STATE OF VERMONT
AGENCY OF TRANSPORTATION

PROPOSED IMPROVEMENT
BRIDGE PROJECT
TOWN OF CAVENDISH
COUNTY OF WINDSOR
VT 131 (MAJOR COLLECTOR)
BRIDGE NO 1

RECORD PLANS

CAVENDISH ER BRF 0146(13)

ANCHOR BOLT PLAN

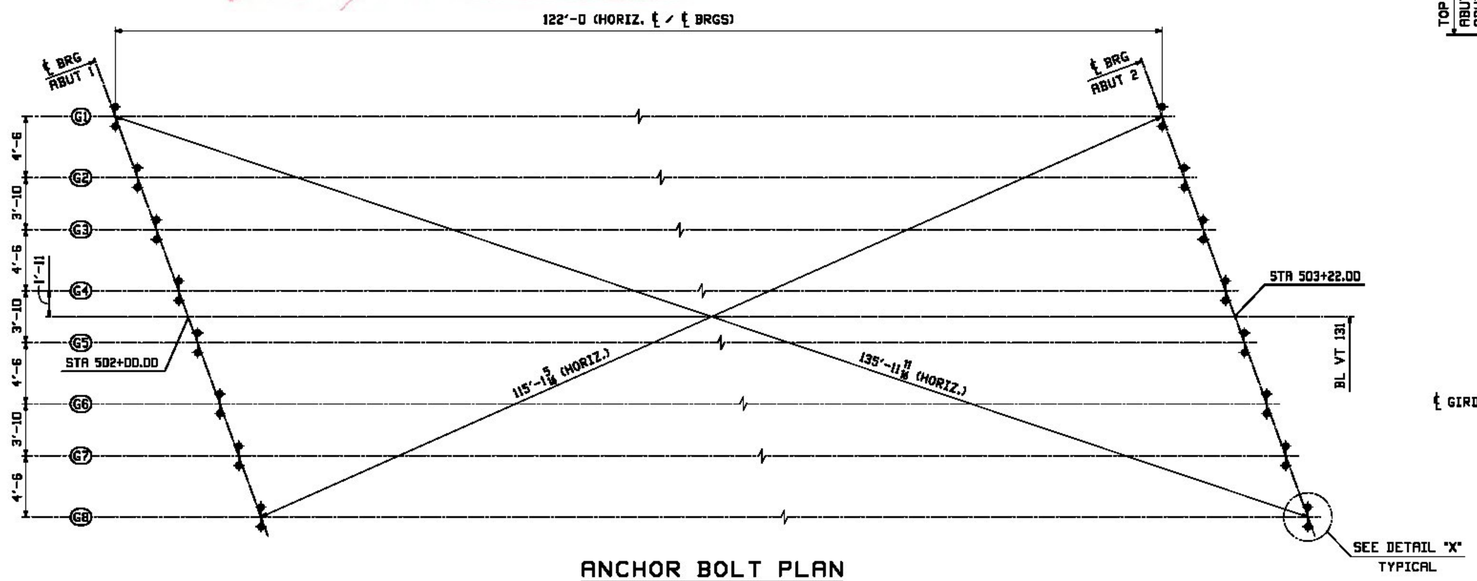
NOTE: REVIEW OF THIS DRAWING IS FOR BEARING ASSEMBLY CONFORMANCE ONLY

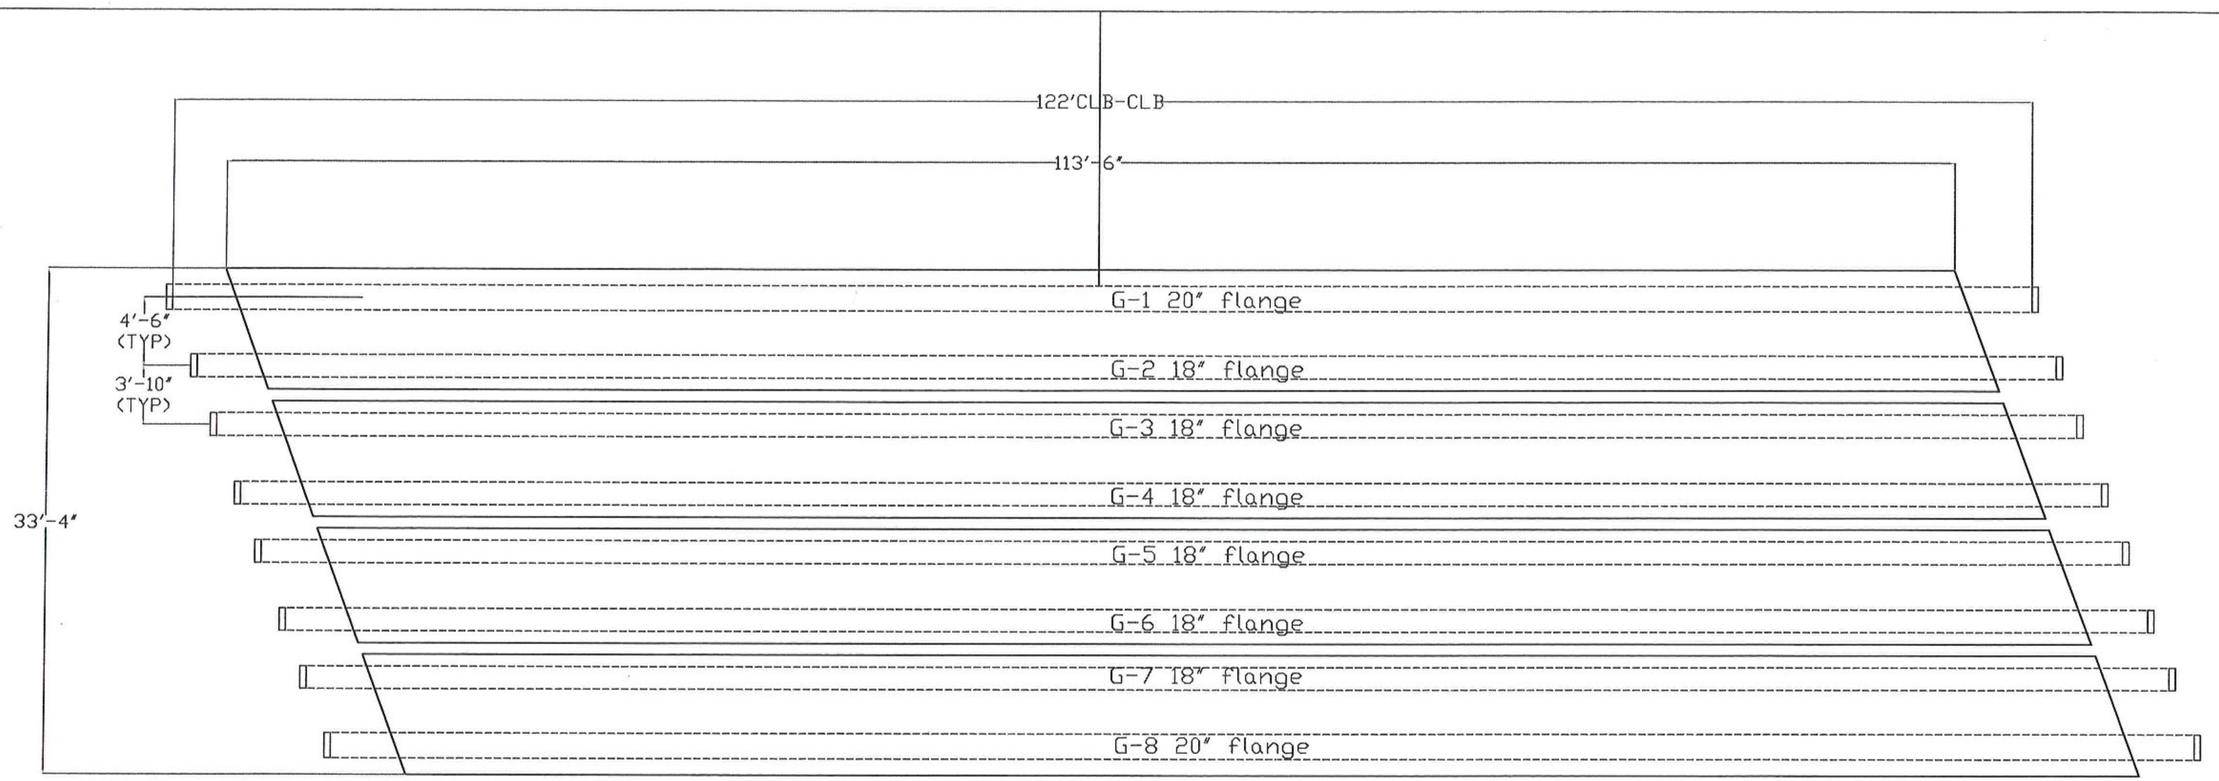
It should be understood that the Erection plan needs to be submitted and accepted before the structural steel gets to the site.

APPROACH SLABS E,F,G,H
CASTING LAY-OUT

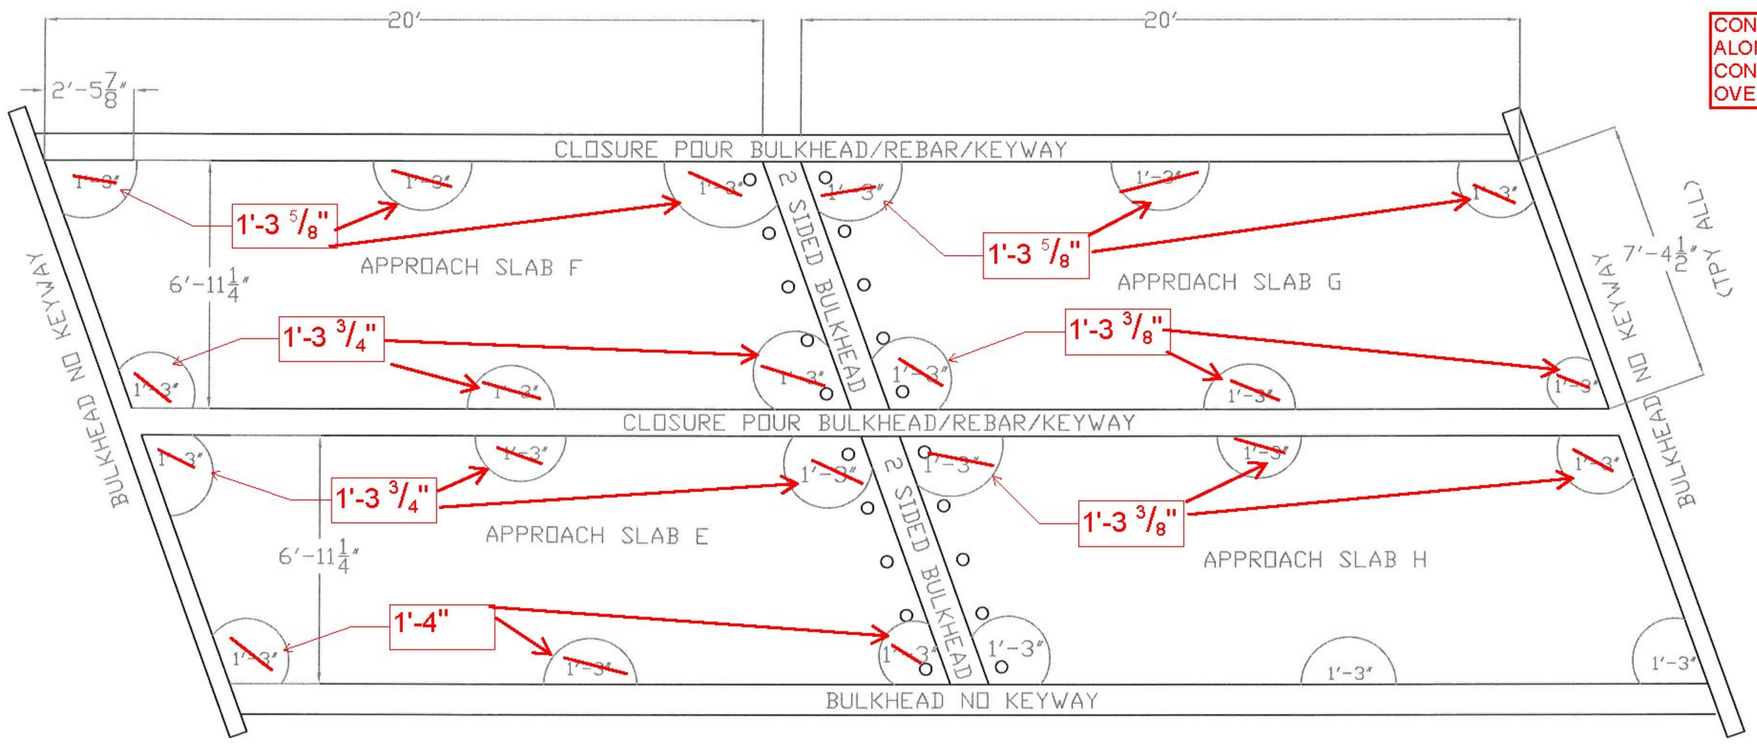
APPROACH SLAB # 2 THICKNESS HAS BEEN CHANGED BY THE PROJECT MANAGER TO A CONSISTENT 1'-3"

CONSTANT THICKNESSES ALONG EDGES, BUT NOT CONSTANT THICKNESS OVERALL

ABUTMENT 2 BEARING LAY-OUT

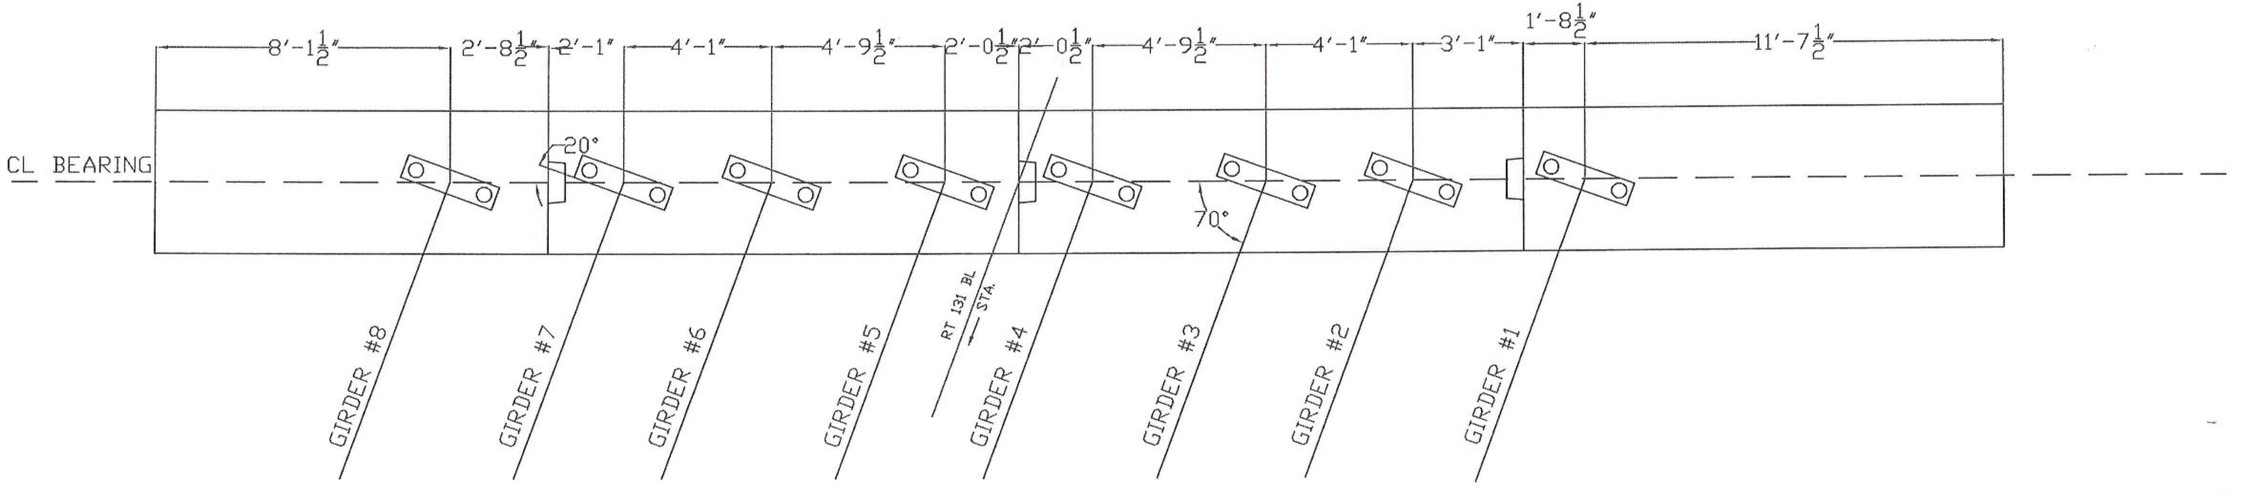
REVISED DIMENSIONS FROM FACE OF VERTICAL CONSTRUCTION JOINT
